Agenda Item # 6

SUB-003436-2025

Resubdivision of Lots 1-3, Block 9, Property of Woods' et. al. at Plateau, Alabama

APPLICATION NUMBER 6 DATE September 18, 2025

DETAIL SITE PLAN

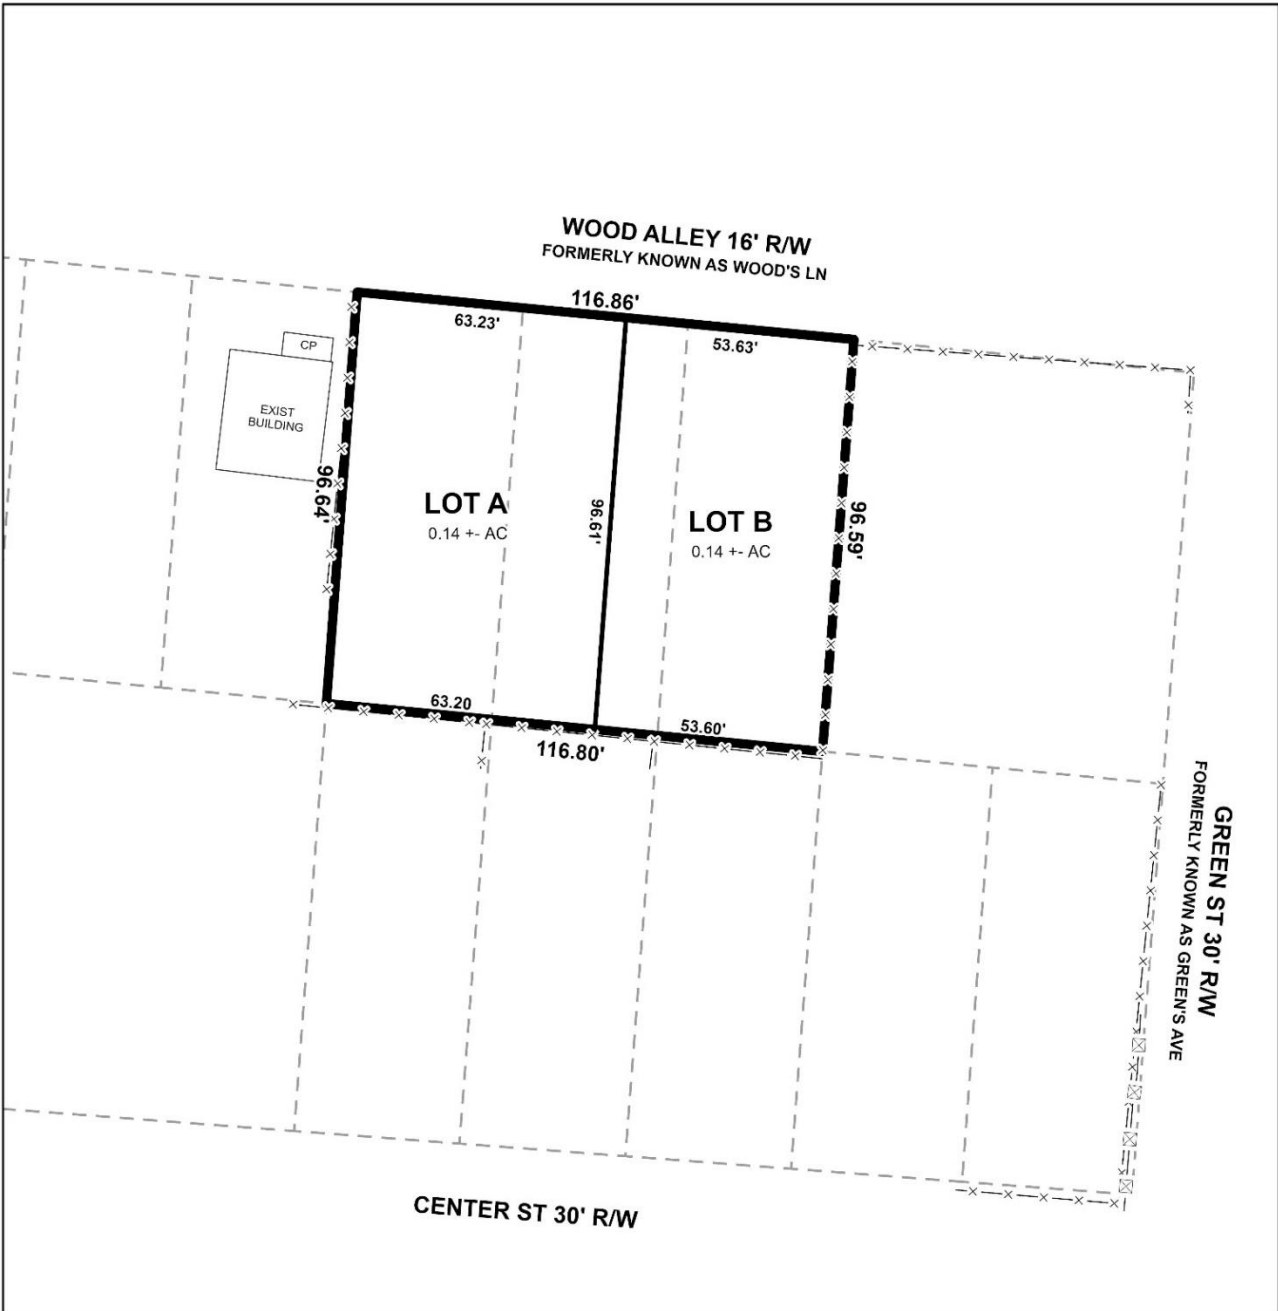
The proposed lots have frontage on Wood Alley, a minor street without curb and gutter requiring 60-foot right-of-way widths. Wood Alley is shown as having an existing right-of-way of 16-feet. As such, if approved, the plat should be revised to illustrate dedication sufficient to provide 30 feet from the centerline of Wood Alley, unless a waiver of Section 6.B.9. of the Subdivision Regulations is recommended by the City Engineer and Traffic Engineer.

The preliminary plat submitted does not depict any required setbacks. A 5-foot front yard setback is required for lots in the R-1, Single-Family Residential Urban District, per Article 2 Section 64-2-5.E. of the Unified Development Code (UDC). As such, if approved, a 5-foot front yard setback should be illustrated along Wood Alley on the Final Plat, if approved, adjusted for any required dedication.

1. Revision of the plat to illustrate dedication sufficient to provide 30 feet from the centerline of Wood Alley, unless a waiver of Section 6.B.9. of the Subdivision Regulations is approved;

3. Revision of the plat to depict a 5-foot front yard setback along Wood Alley, adjusted for any required dedication;
4. Placement of a note on the Final Plat stating development of the site is subject to the applicable provisions of Article 11 of the UDC regarding the Africatown Overlay and Africatown Safety Zone regulations;
